Engineers Comments Regarding Surface Water Drainage

Application Reference:	CM/6/24/DOC	Reviewer Reference:	ADC/EXT12/GK
Planning Officer:	Jessica Riches	Date of Review:	01.10.2024
Site Name:	Land to the West of Church Lane and South of Horsemere Green Lane Climping		
Application Description:	Approval of details reserved by condition imposed under CM/1/17/OUT relating to conditions 6-Phasing Plan and Programme , 8-Arboreal Method Statement, 9-surface water drainage scheme, 10-discharge of flows to watercourses or the culverting, diversion, infilling or obstruction of any watercourses on site , 11-Flood Management and Mitigation scheme, 12-Ecology Management and Mitigation Plan, 13-archaeological works, 14-Constuction Method Statement, 15-Travel Plan, 16-energy efficiency measures, 17-acoustic barrier, 21-Employment and Skills Plan and 22-provision of broadband.		
Assessment Number:	2 of 2

NoApplication Reference: CM/6/24/DOC	Initial Issue Date:
Site Name: Land to the West of Church Lane and South of Horsemere Green Lane Climping	Issue Date: 02/01/2024
	Reviewer Reference: ADC/EXT12/GK

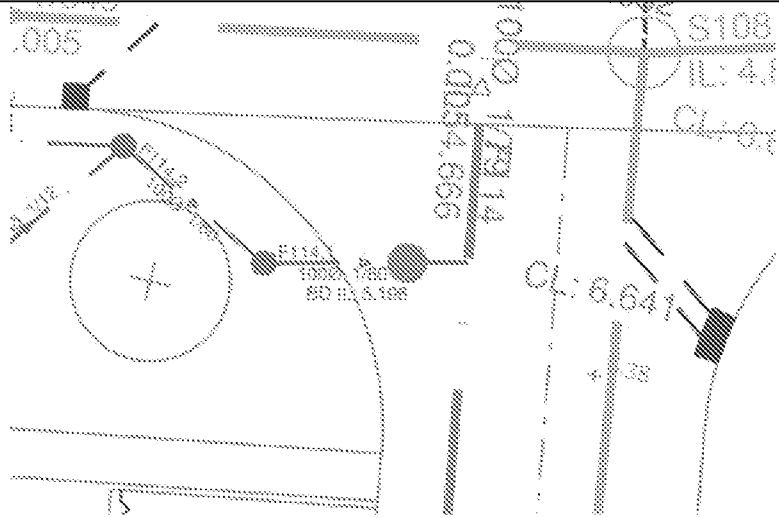
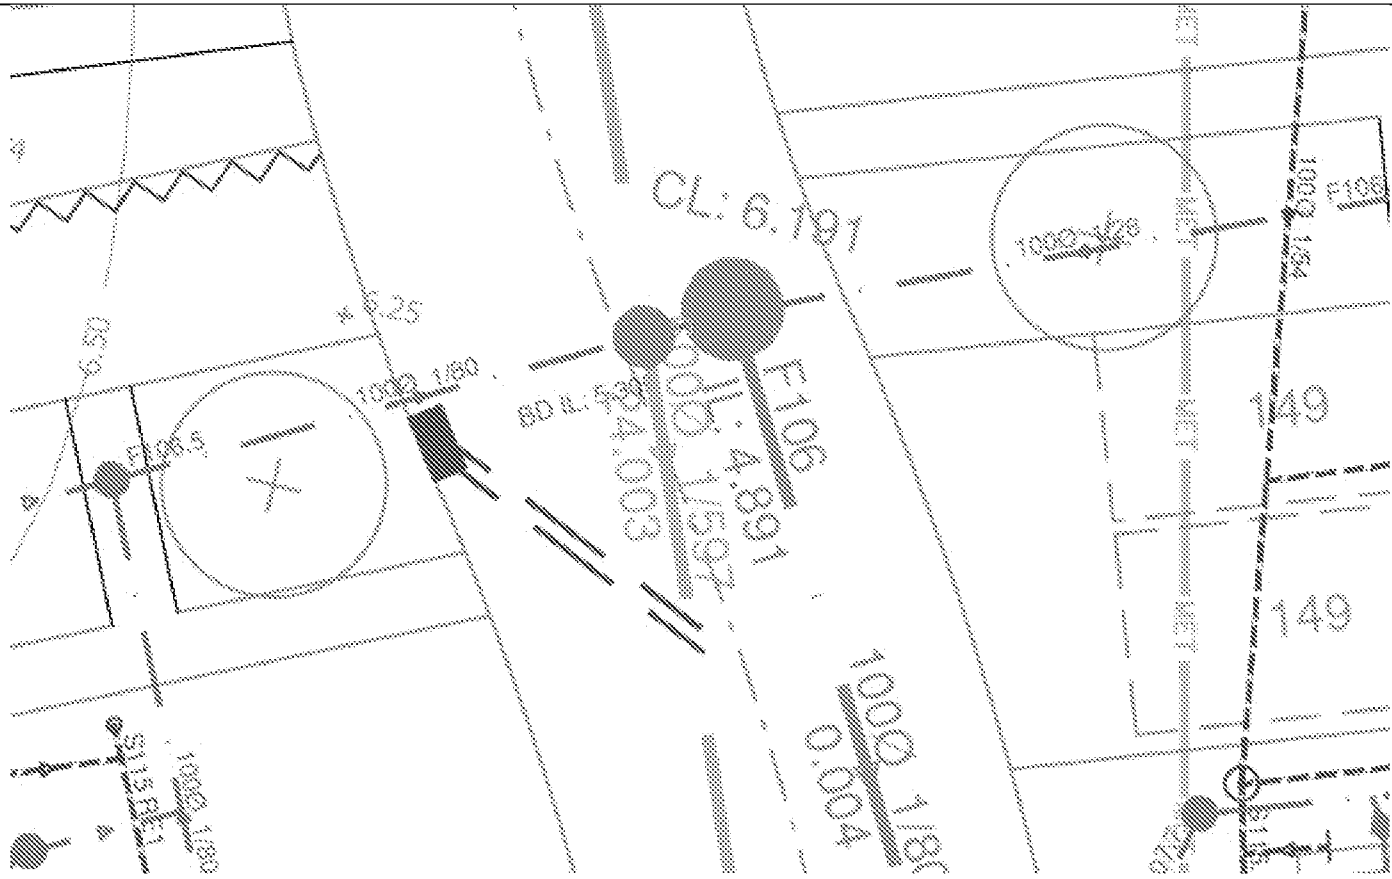
1.	The phasing plan is to include the relevant attenuation/infiltration basins.	No update.	Even though the updated phasing plan has been updated in accordance with the instructions of Jessica Riches (email 27/8/2024) it is still not clear where is the attenuation for each phase. Please present it on your drawing so it is clear that for each phase the drainage will be independent following the completion of its works.		
Condition Number: 9 [Surface water drainage design]
